EOG Resources requests an amendment to our APD for this well to reflect a change in casing.

EOG RESOURCES, INC.
DILLON 31 FED COM NO. 3H
REVISED 3/27/12

Dillon 31 Fed Com #3H
Pitchfork Ranch
Lea County, New Mexico
Revised 3/27/12
Proposed Wellbore

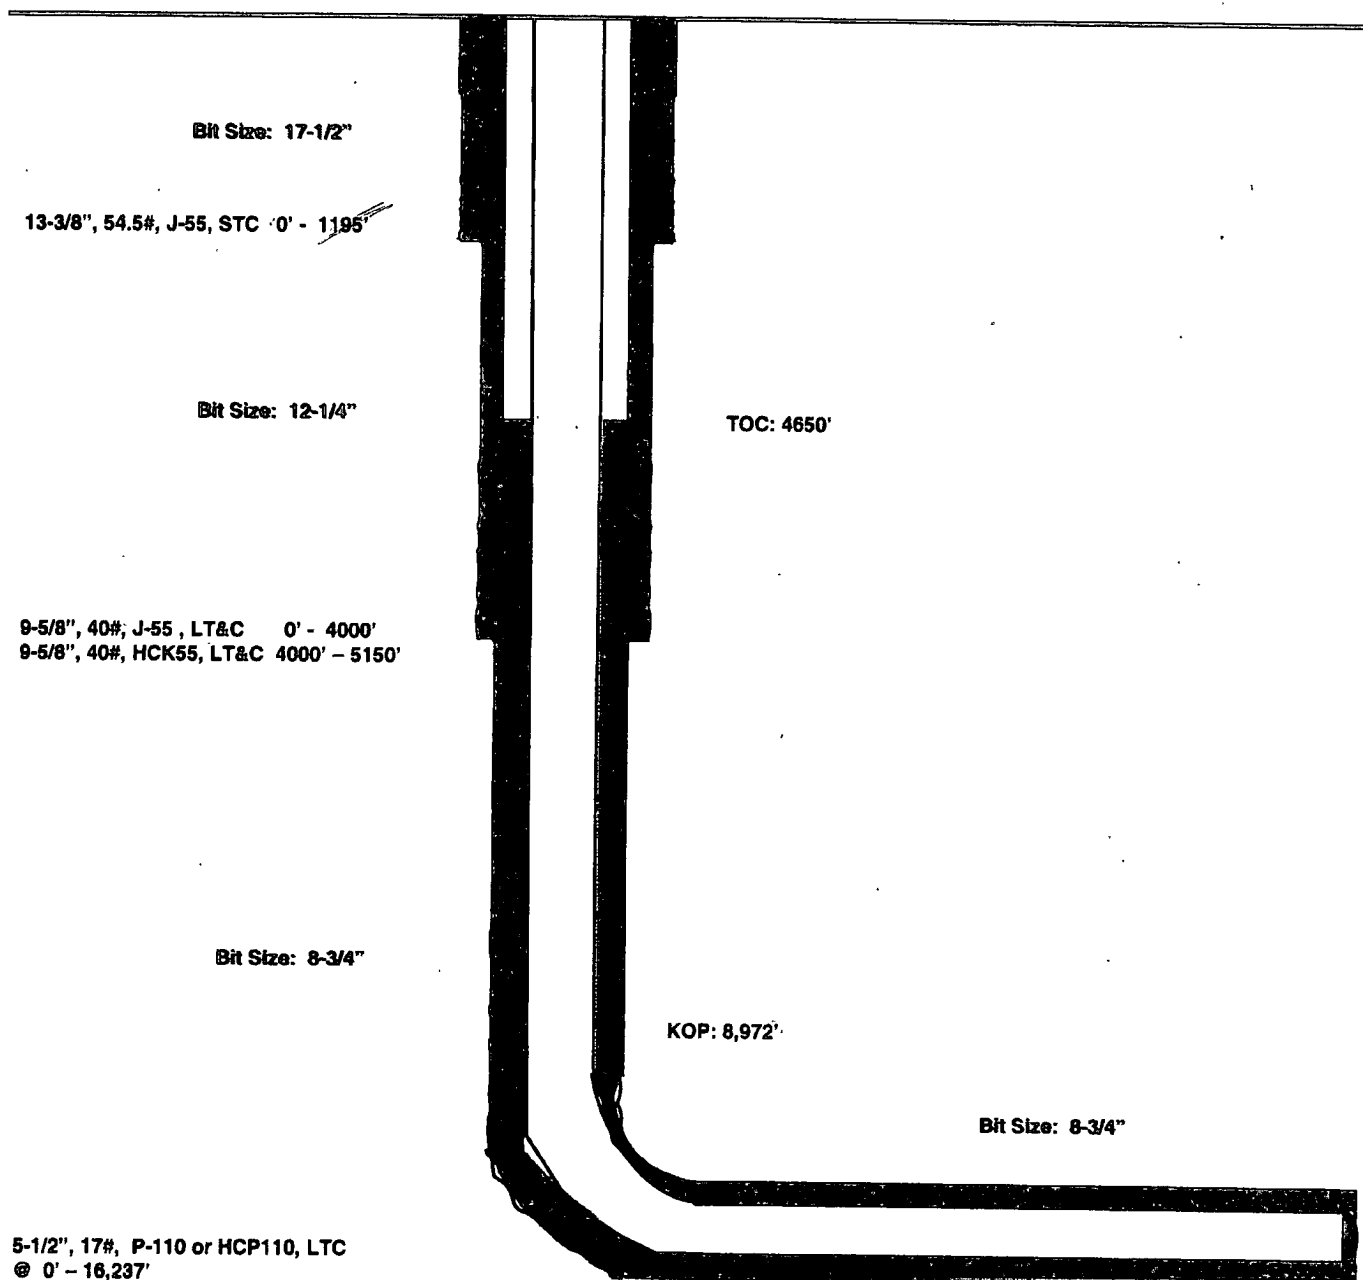
From 11-3/4", 43#, H40 STC to 13-3/8", 54.5#, J55 STC
From 8-5/8", 32#, J55/HCK55 LTC to 9-5/8", 40#, J55/HCK55 LTC
From 5-1/2", 20#, HCP110 NSCC to 5-1/2", 17#, P110 or HCP110 LTC

Hole Size	Interval ¹²⁵⁵	Csg OD	Weight	Grade	Conn	DF _{min} Collapse	DF _{min} Burst	DF _{min} Tension
17.5"	0 - 1195'	13.375"	54.5#	J55	STC	1.125	1.25	1.60
12.25"	0 - 4000'	9.625"	40#	J55	LTC	1.125	1.25	1.60
12.25"	4000' - 5150'	9.625"	40#	HCK55	LTC	1.125	1.25	1.60
8.75"	0' - 16,237'	5.5"	17#	P110 or HCP110	LTC	1.125	1.25	1.60
